# FTI-FDK2: Vehicle Coverage and Preparation Notes

### FTI-FDK2 Harness Bulletin - Type 2 Install (Aftermarket RF)

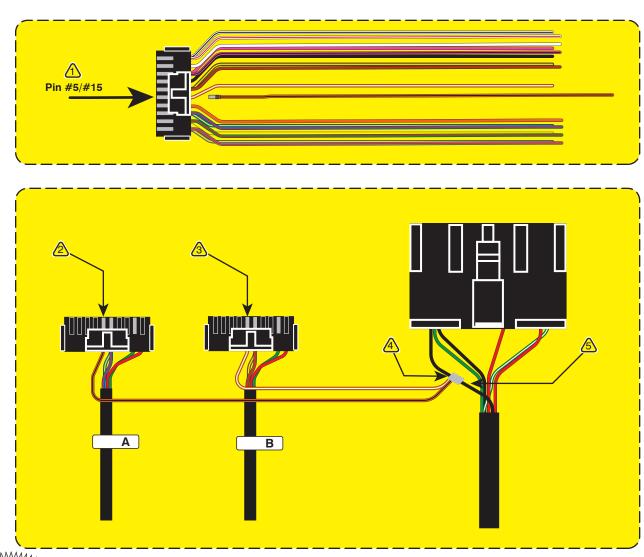
Overview: The initial production release of the FTI-FDK2 harness did not account for the use of aftermarket RF components and does not supply the connection that programs the module for aftermarket RF use. This issue affect the initial release and is currently being addressed in production, but for installations using aftermarket RF a field repair is provided below.

Issue: The orange black wire is not included in the BLADE connector. This wire must be present throughout steps 1 & 2 of the module programming procedure in order for the module to properly control the vehicle's door locks via aftermarket RF. The required wires can be sourced from the harness originally supplied with the BLADE cartridge, inserted into position #5 of each BLADE connector, and attached to either of the black ground wires in the CN1 connector of the harness.

- 1.) Use a pick tool to depress the locking tab on the terminal connector of the orange/black & orange/white wires in pin positions #5 & #15 of the BLADE connector that was supplied with the BLADE module, remove wires for relocation.
- 2.) With locking tab repositioned, insert orange/black wire into position #5 of the connector marked [A].
- 3.) With locking tab repositioned, insert orange/white wire into position #5 of the connector marked [B].
- 4.) Extend the orange/black & orange/white wires to the CN1 connector, strip ends and attach to one of the black ground wires.
- 5.) Once the wires have been securely connected and insulated, you may proceed with module programming.
